**TWIN CITY WATER AND SEWER DISTRICT EAST 1ST ST., UHRICHSVILLE, OHIO
TUSCARAWAS COUNTY, OHIO
PROPOSED
WATER MAIN AND PAVEMENT RESURFACING**

ADDENDUM # 1

**JANUARY 20, 2021
Thrasher Project #101-010-10014**

TWIN CITY WATER AND SEWER DISTRICT
 EAST 1st. STREET, UHRICHVILLE, OHIO
 WATER MAIN AND PAVEMENT RESURFACING
 TUSCARAWAS COUNTY, OHIO
 SANITARY SEWER PROFILES

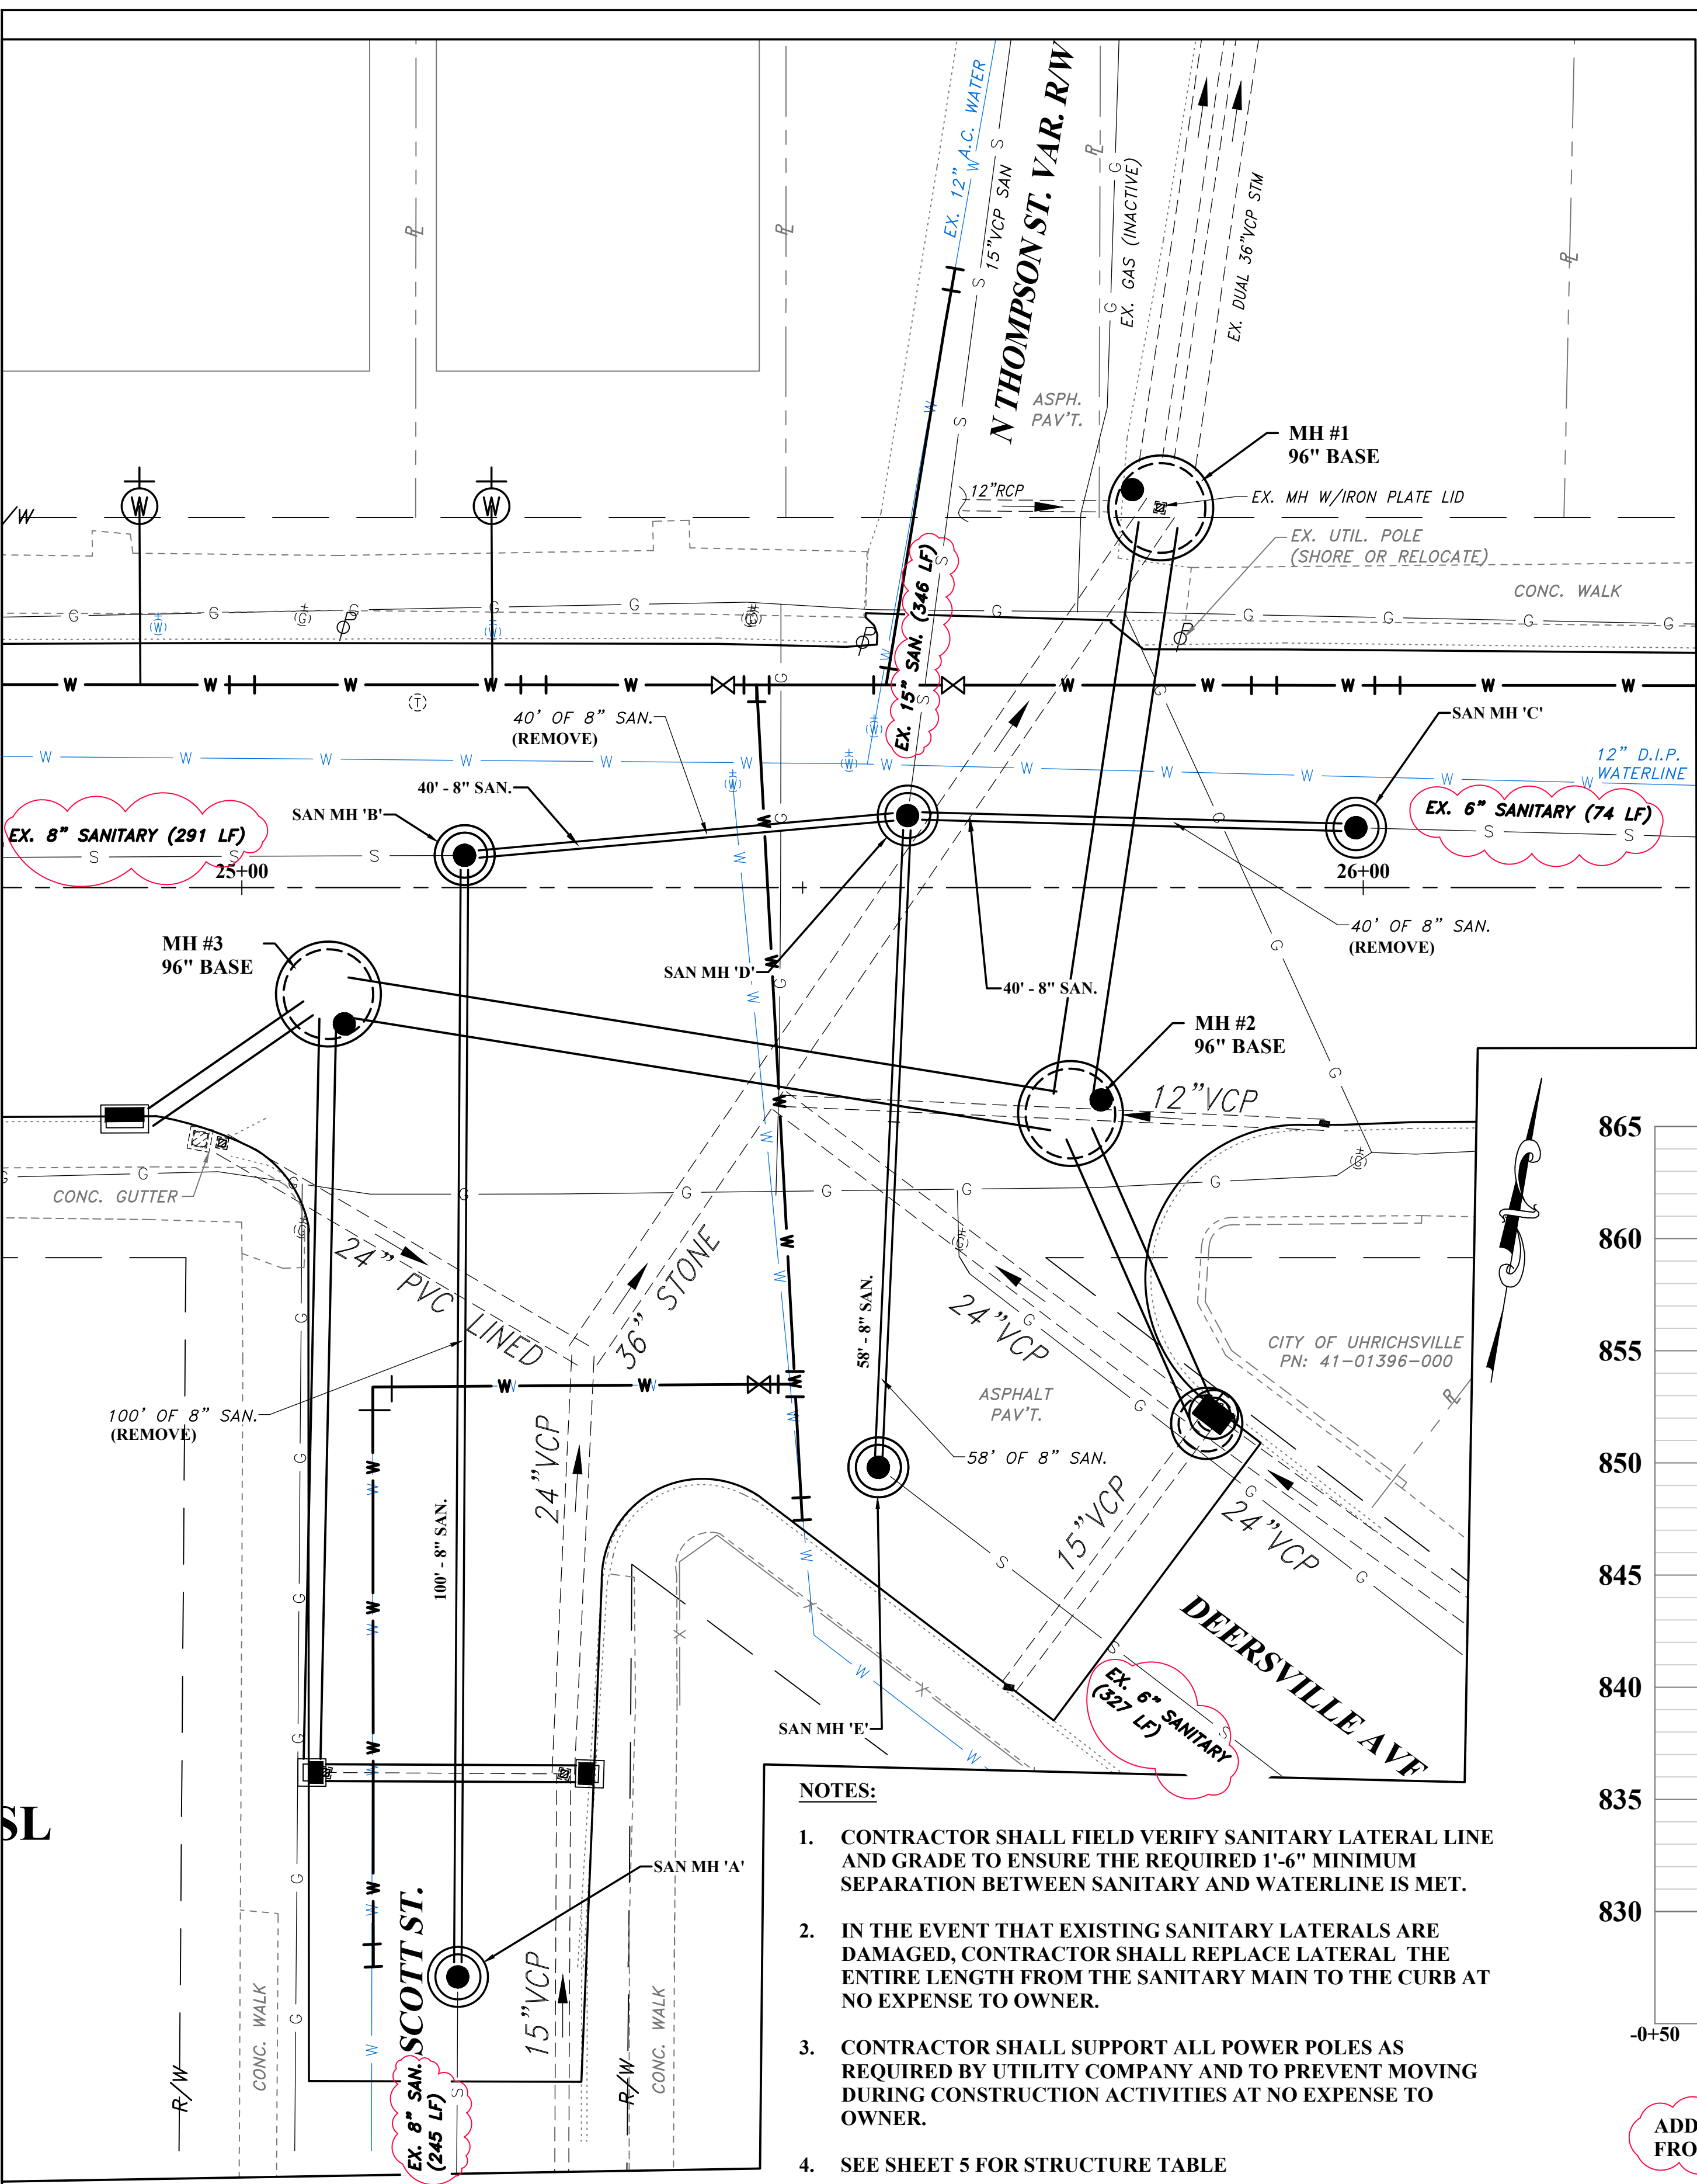
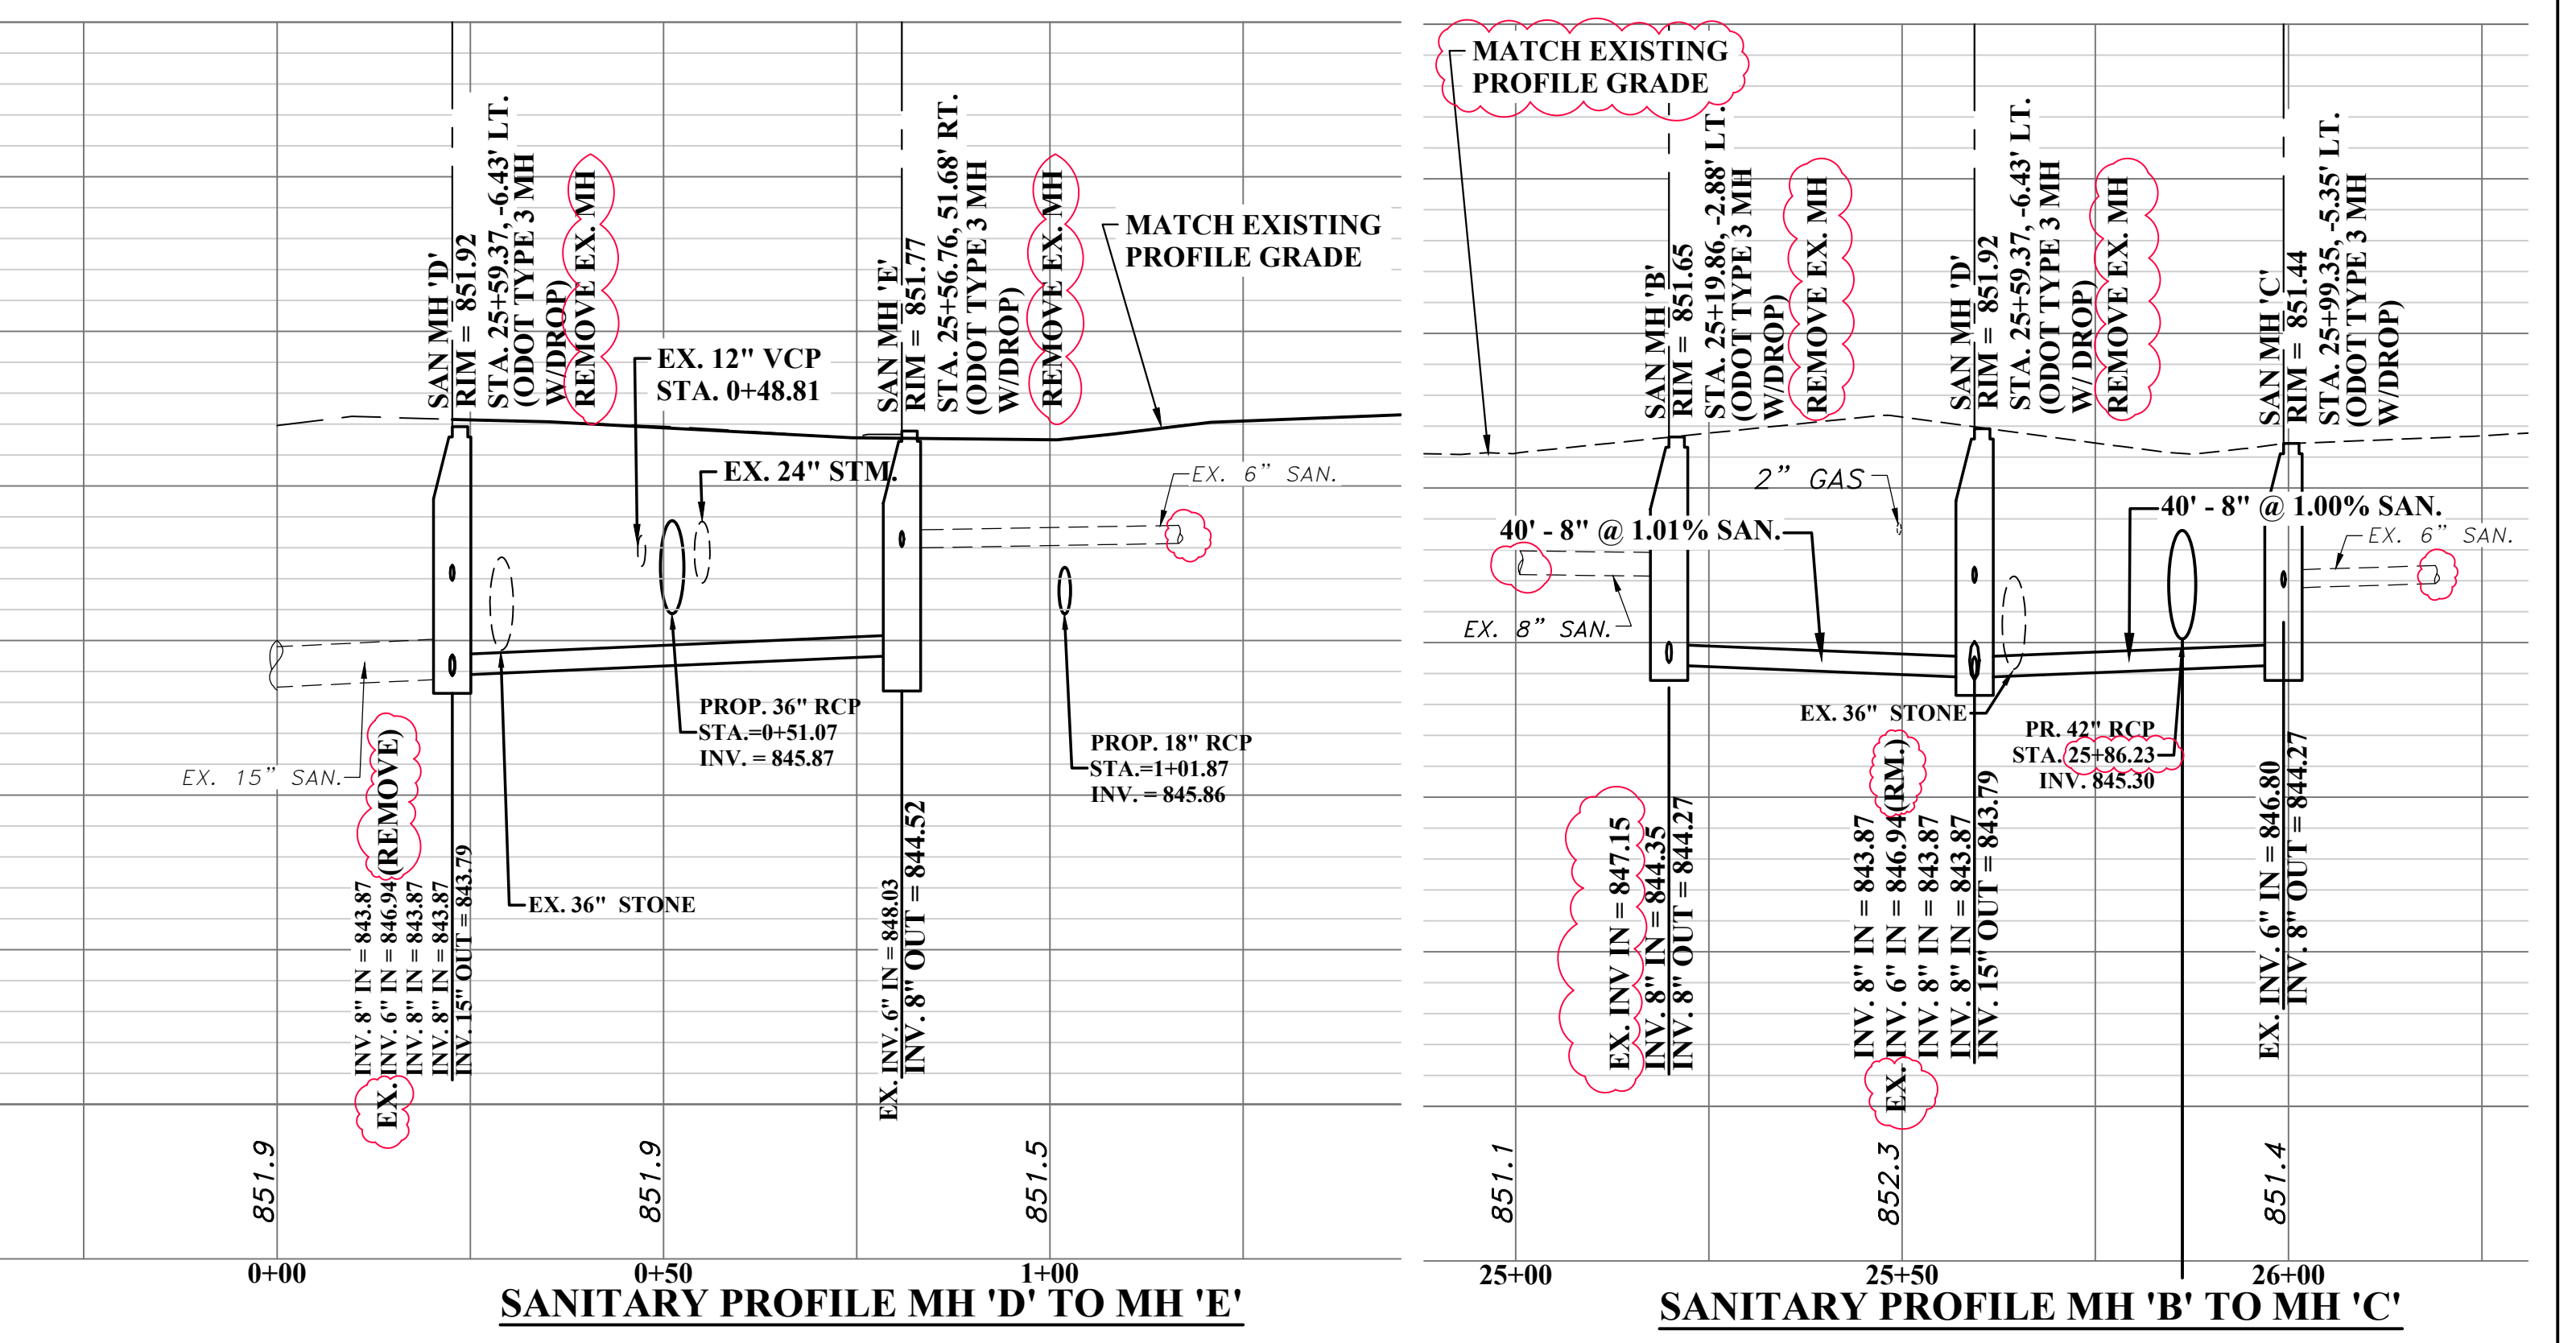
- Changed 8” PVC SDR-35 from 550 LF to 238 LF
7. Plan Sheet 15: Storm Sewer Profiles
 - Added storm sewer text
 8. Plan Sheet 16: Sanitary Sewer Profiles
 - Removed the text “Remove and Replace” from sanitary manholes A,B,C and E
 - Revised existing sanitary text
 9. Plan Sheet 19: Standard Details
 - Changed waterline trench detail with crushed stone cover to sand
 10. Plan Sheet 20: Standard Details
 - Changed Utility Trench Detail label to read Storm/Sanitary Utility Detail
 11. Plan Sheet 22: Standard Details
 - Added Sanitary Manhole Drop Structure detail
 12. Plan Sheet 24: Standard Details
 - Added Catch Basin/Manhole #4 Detail
 - Changed the max outlet diameter for MH#4 Detail from 24” to 30”

ADDENDUM#1 NOTE: REMOVED THE TEXT "REMOVE AND REPLACE" FROM SANITARY MANHOLES A AND C.

NO.	BY	DATE	DESCRIPTION
1	JAB	1/19/21	ADDENDUM#1 - EX. SANITARY LINE/STRUCTURE TEXT CLARIFICATION
